**REQUEST FOR BIDS (20-08)
Re-Roofing Project**

**Addendum No. 2
Addendum Issue Date: September 17, 2020**

This addendum is being issued to provide additional bidding information.

LANSING AIRPORT AREA "O"

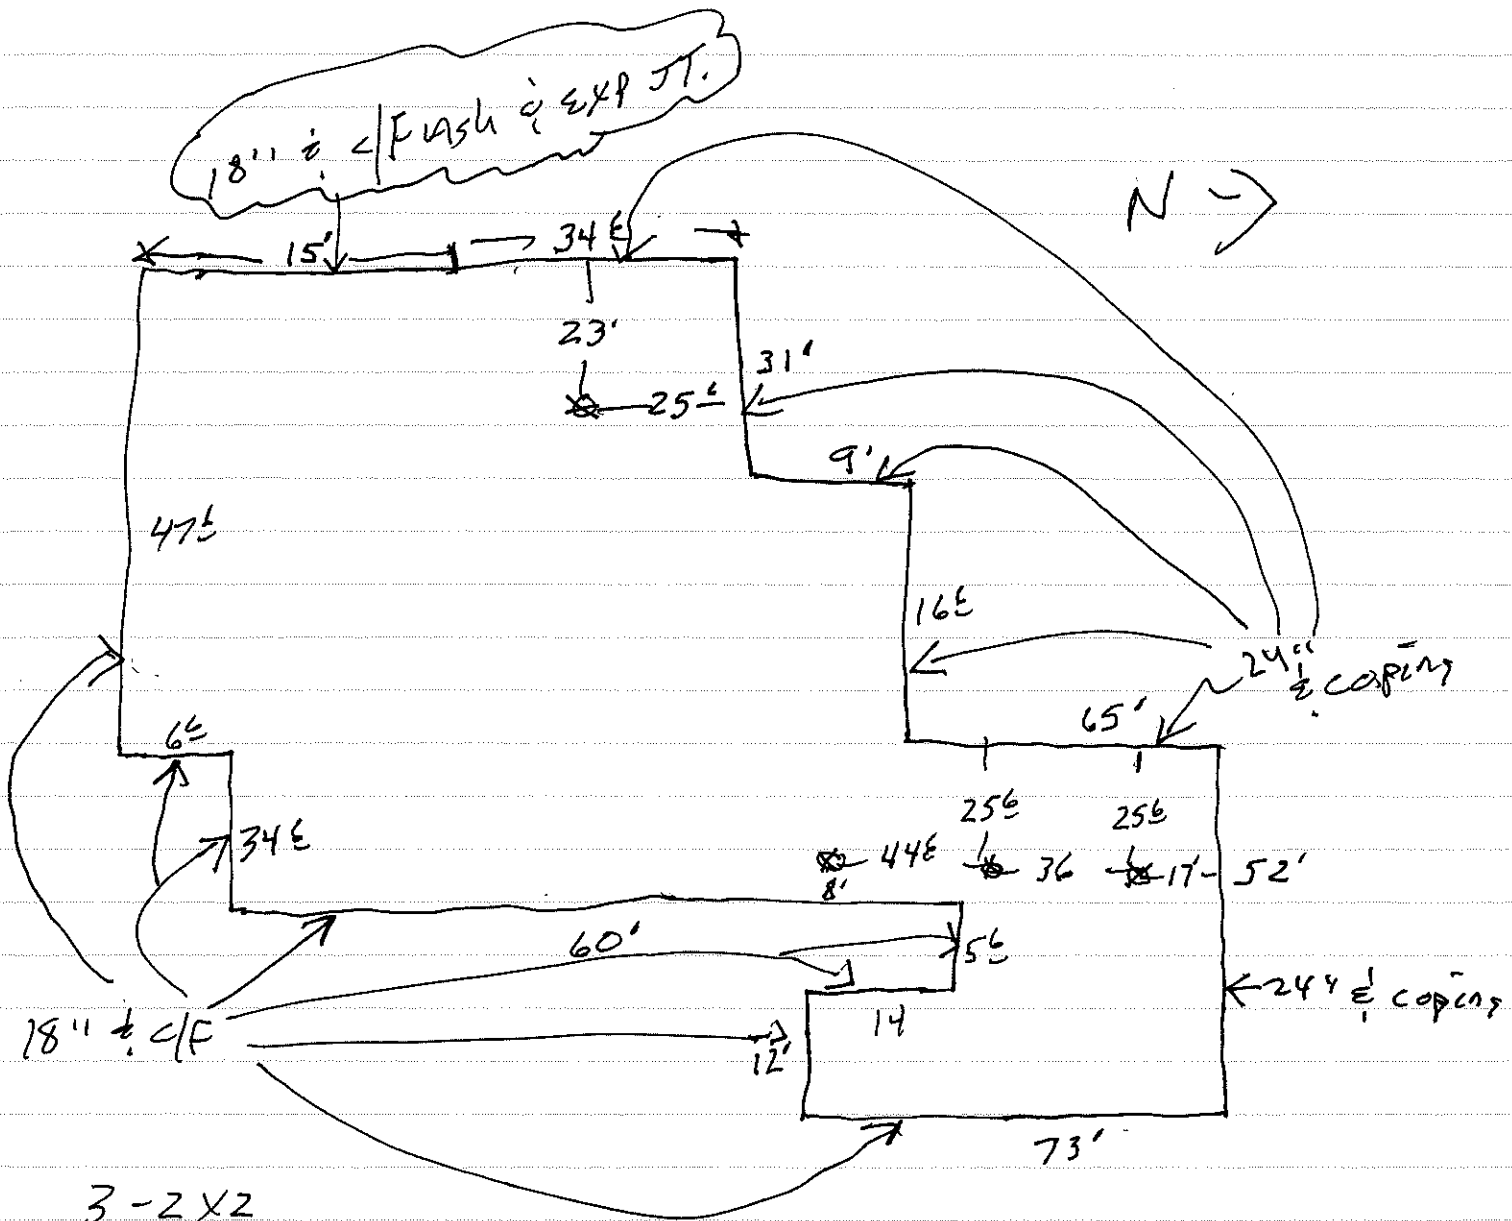
- 3-2X2
- 3-UTR
- 2- Pipes - 4" support
- 5- Downspouts from upper roof DRAIN onto this roof
- 2- 3'X3' curbs
- 100' GAS pipe NEED Supports & PADS
- NEED WALKPADS & STAIRWAY AND AT ACCESS LADDER

LANSING AIRPORT AREA "M"

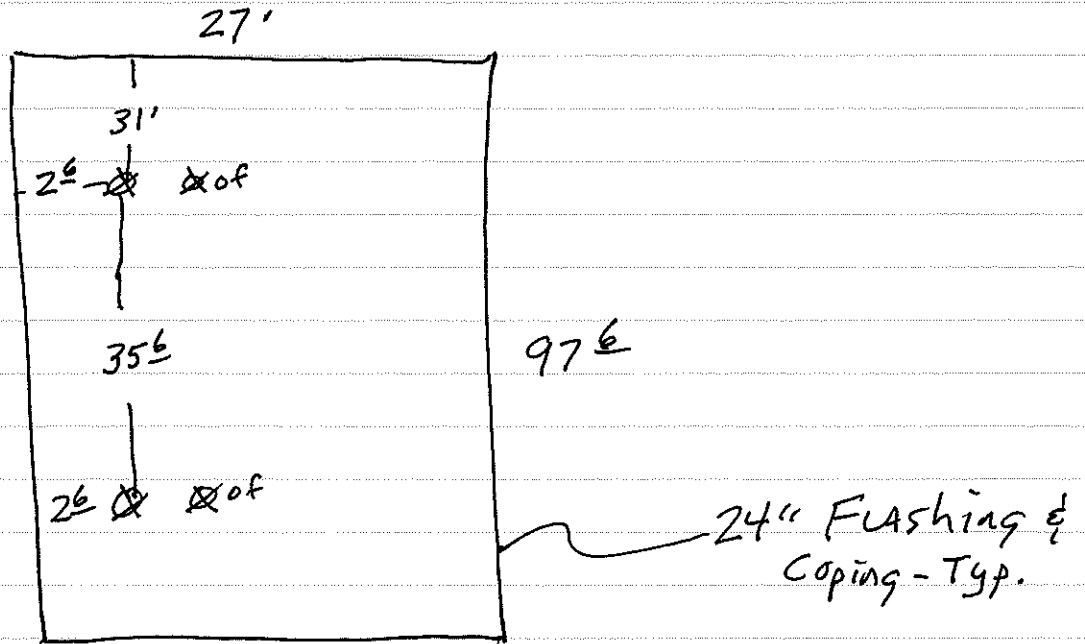
* 7- ANTENAS they will MOVE
WILL NEED WALKPAD UNDER ?
